**From:** Zoning Board of Appeals  
**Subject:** FW: Variance Appl. 3 20-00305 233 Hillspoint Rd.  
**Attachments:** 233HillspointTablenew.pdf

Site Photo 12/20/2019	Approved ZBA #7629 Plans	Plans submitted by applicant for Revoked Zoning Permit # 42345	Planned ZBA #7592 Plans
Location of Elevator Shaft		 		 
The elevator shaft has been constructed in the same location as the denied ZBA #7592 plans. This is not in the location that was approved by ZBA #7627.	Plans submitted for the Revoked Zoning Permit #42345 also do not show the elevator shaft in this location.	Since the elevator shaft has been pulled forward, it is likely that the roof top deck is larger than approved, as seen in the denied ZBA #7592 plan.	A side entry has been constructed that is inconsistent with ZBA #7627 approval.	The spiral staircase that was approved per ZBA #7627 is no longer present in the field or on the plans submitted for the Revoked Zoning Permit.
New Side Entry			Plans submitted for the Revoked Zoning Permit #42345 do not show this landing either.

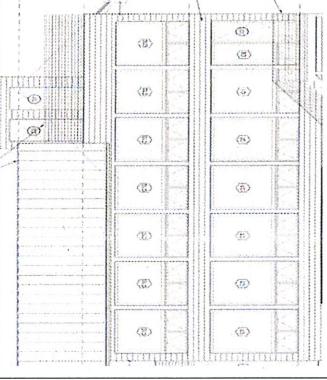
A condition of ZBA #7629 approval was that the brick walkway be retained. The walkway is currently asphalt and the width is not equivalent to what was on the ZBA approved plans.

The wall was not present on site on 12/19/20 and 12/20/2019 as documented by staff photos.

The wall is not present in either the approved ZBA #7629 plan or the Revoked Zoning Permit.
